TRANSMITTAL

Perkins Bridge over Black Stream
Levant - Penobscot Co, ME

HSS Job No. 1230178A-1 ~ PDC Action/Reply plan to Approval Comments

PDC Action/Reply plan to Approval Comments received from High Steel in the following file [Multi YY01 A-1 12-13-2023 (Submitting for Approval)_BJB.pdf] (16 pages)

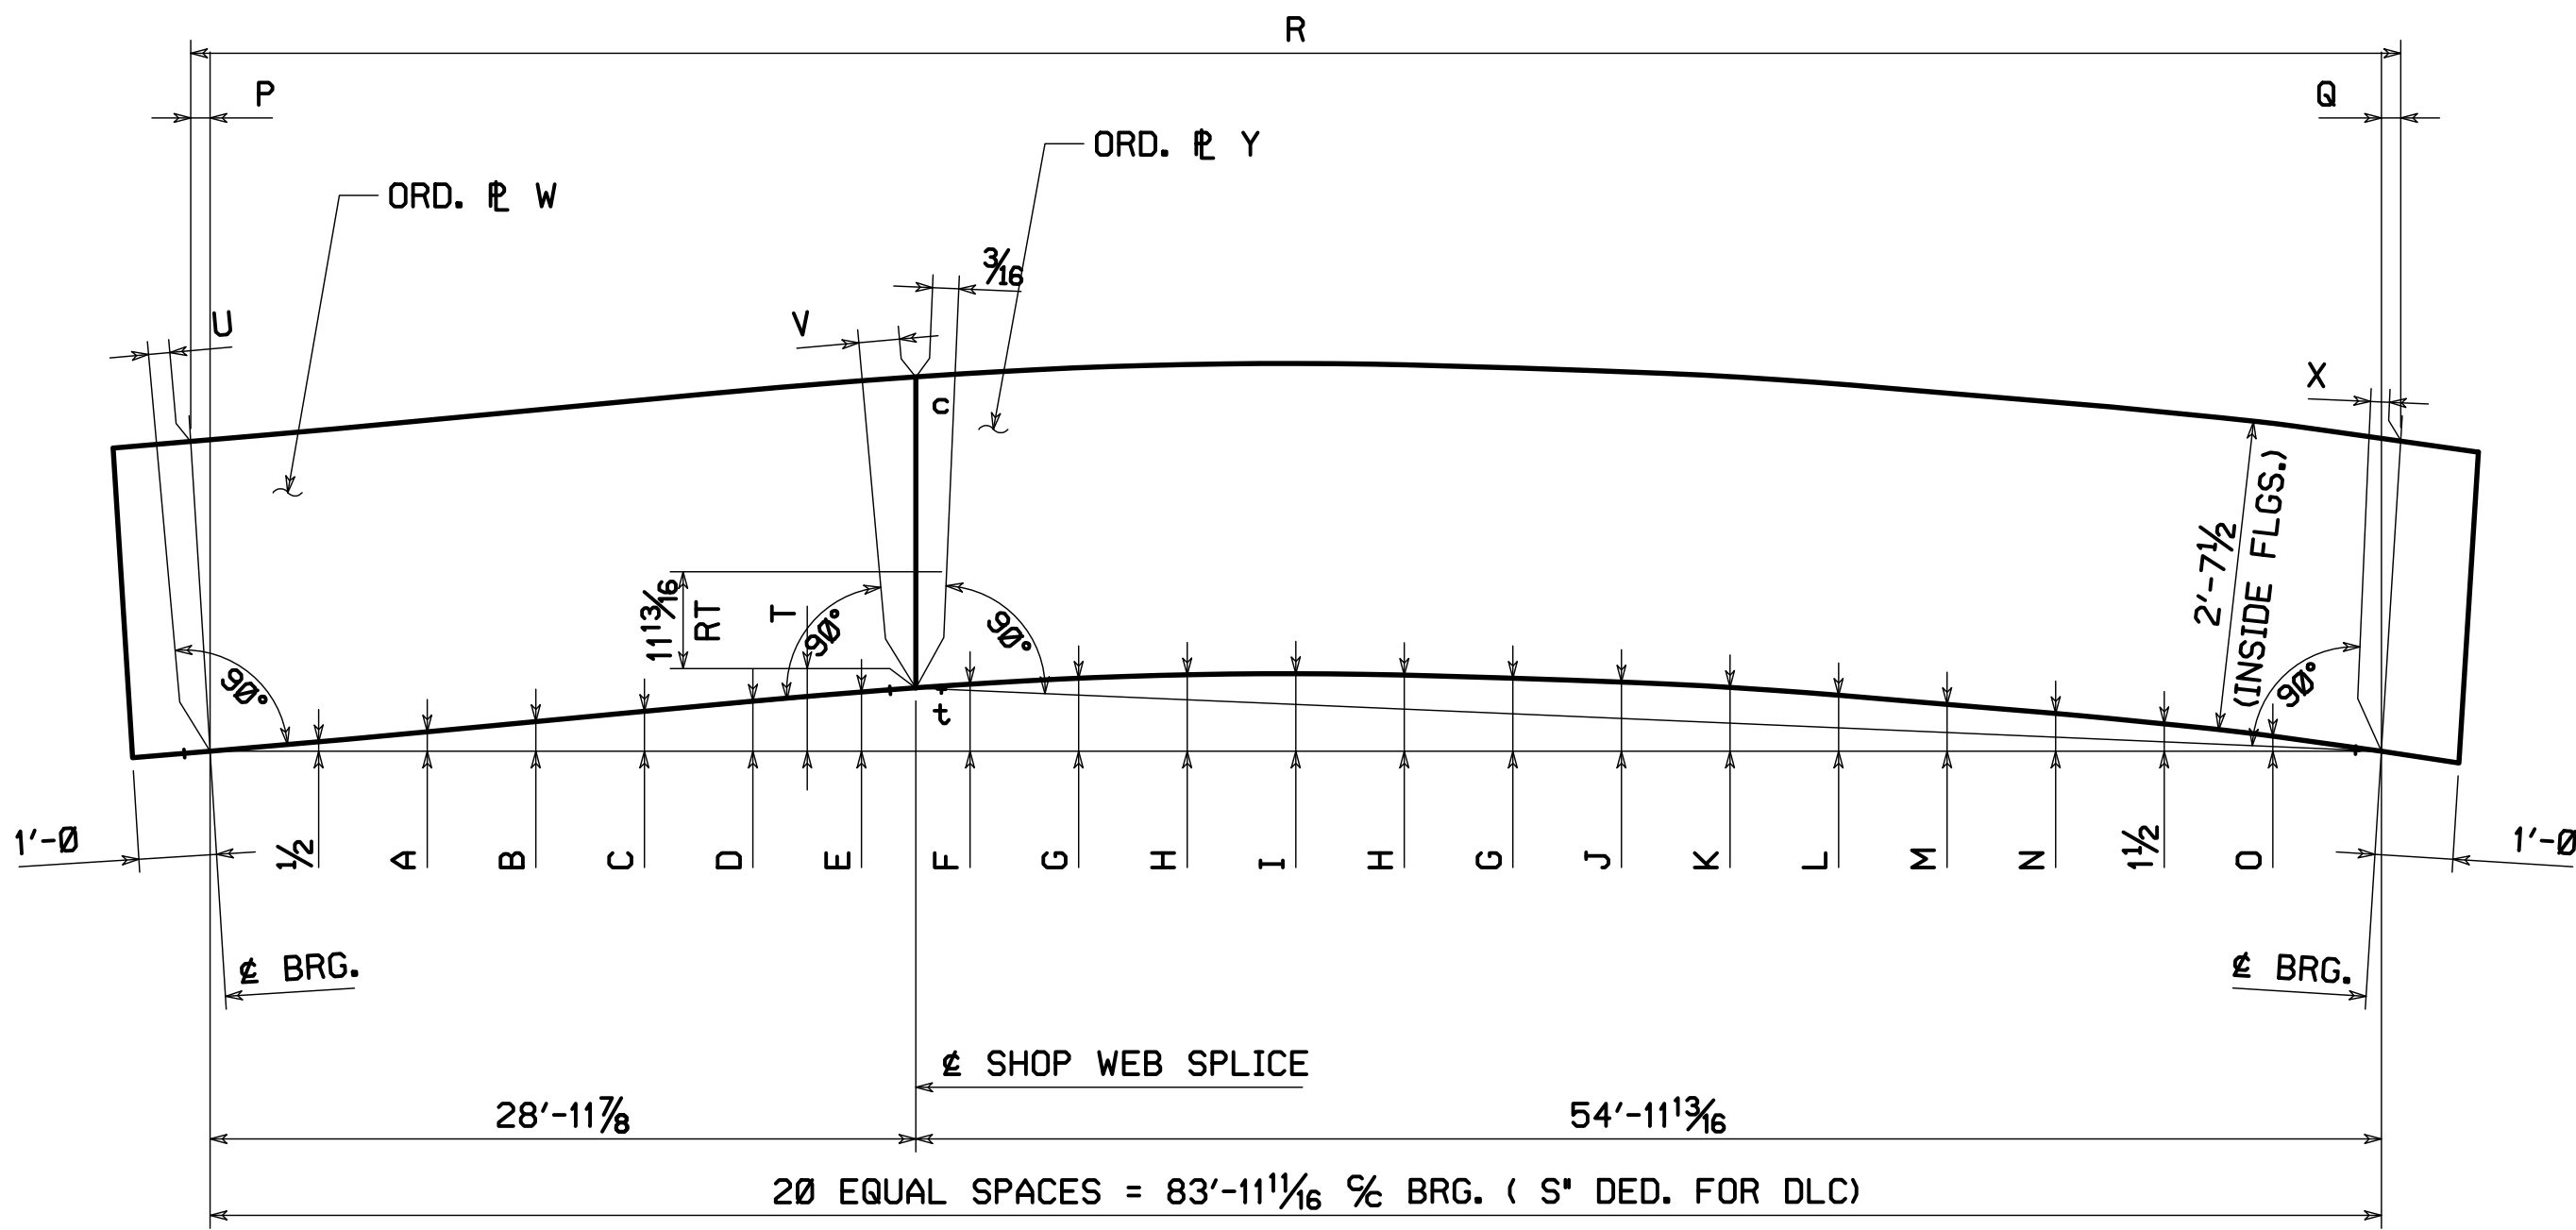
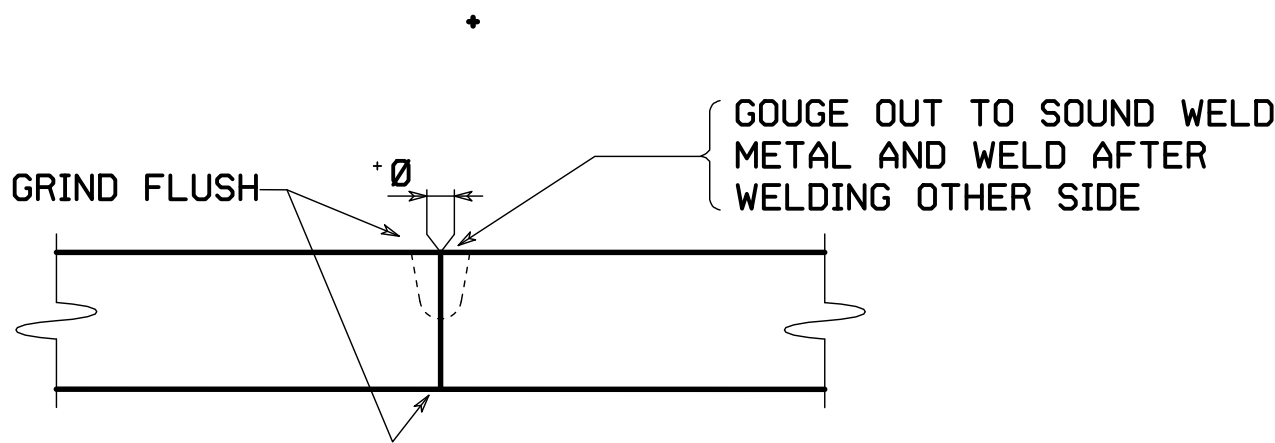
Item	pdf	Dwg No.	Approval Comment	PDC Action/Reply plan	PDC additional verification/steps
1	8	WC1	- Some of these don't match up with camber ordinates on Contract Plan sheet 4. - Math doesn't seem right. 35 less 3.75 is less than 31.5	- Approver is pointing out TABULATED Camber ordinates "J/K/L/M/N/O" and asking the question. The ordinates detailed do match the design sheet Camber Diagram ordinates, however High Steel provides 20 equal spaces instead of the 10 spaces shown on designs. Ordinates "I / G/ K/ M/ 1 ½" " match the exact values of design 10th points while ordinates " J / L / N / O " are interpolated half points between the 10th points and their values are correct as detailed as well. - Approver seems to be subtracting 3.75" from the ordered 35" web depth and getting a result of 31.25" which is less than nominal web depth of 31.5". The 35" ordered depth for the 1st Pc of Web covers the 31.5" nominal web depth plus approximately ½" camber required for the 1st Pc midpoint which is 32" sufficient.	- Hi steel COGO program would have alerted the detailer's if there were camber irregularities in the profile of web. - Hi Steel COGO program calculates required Camber automatically then adds an additional 2.5" to the calculation to ensure ample width for web cutting and heat adjustment.
